**PRODUCT / PROCESS CHANGE NOTIFICATION**  
**PCN-000751**  
**Date: 12-29-2021**

**Site Transfer**  
**P/N TS14002-CXXXDFNR**

**PCN No. 000751**  
**Qualification of Carsem Ipoh for TS14002-C0XXDFNR products**

### Assembly Process Flow Comparison for CarsemSZ (Old) vs. CarsemIPH (New)

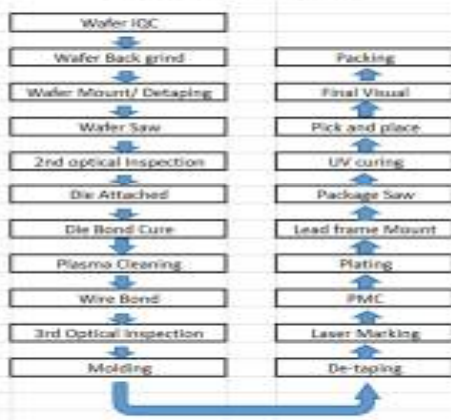
- No major Change in manufacturing Flow for both Assembly site CarsemSZ versus CarsemIPH except additional process step for plasma cleaning before mold for Carsem Iph.
